PERMIT NUMBER: B 21001968

RESIDENTIAL BUILDING PERMIT APPLICATION

Street Address: 705 RIDGE RD.
City: MOUNT AIRY State: MD Zip Code: 21771
Subdivision/Village/Complex Name: SDP/WP/BA #:
Lot: Tax Map: 325877 Parcel: Grading Permit #:

10' X 24' DECK 10' X 20' addition

240-782-8354	
101 BAYBRIDGE TERRACE GAITHERSBURG, MD 20878	
ADDRESS 101 BAYBRIDGE TERRACE GAITHERSBURG, MD 20878	DATE 7-15-21
DRAWN BY DATE PROJECT NO. 981-021	SHEET NO. A001

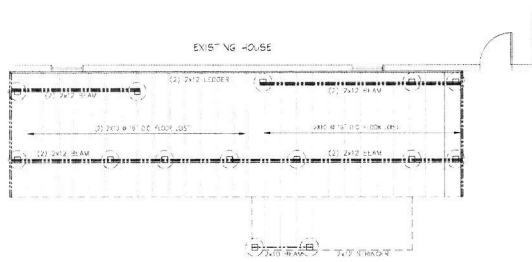
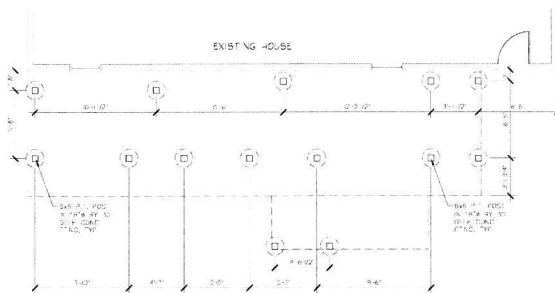
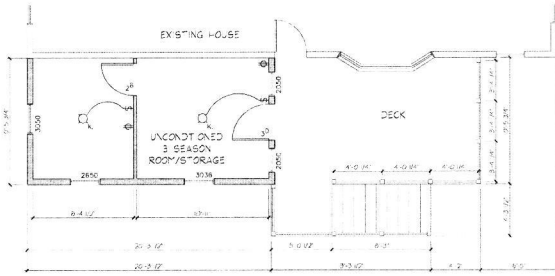
Sorry. I missed that the one attachment had multiple pages. Looking at the floor plan, is that second room also unconditioned space? It looks like there is a window in the existing house in that area that is not shown on the proposed plan, is that being walled off?

It looks like the shed is elevated and attached to the house. If this is not conditioned space attached internally to the house, we need a simple sketch floor plan of the shed area and that portion of the house with a note that it is unfinished, unconditioned space.

Yes that is unconditioned space and the window will be sealed.
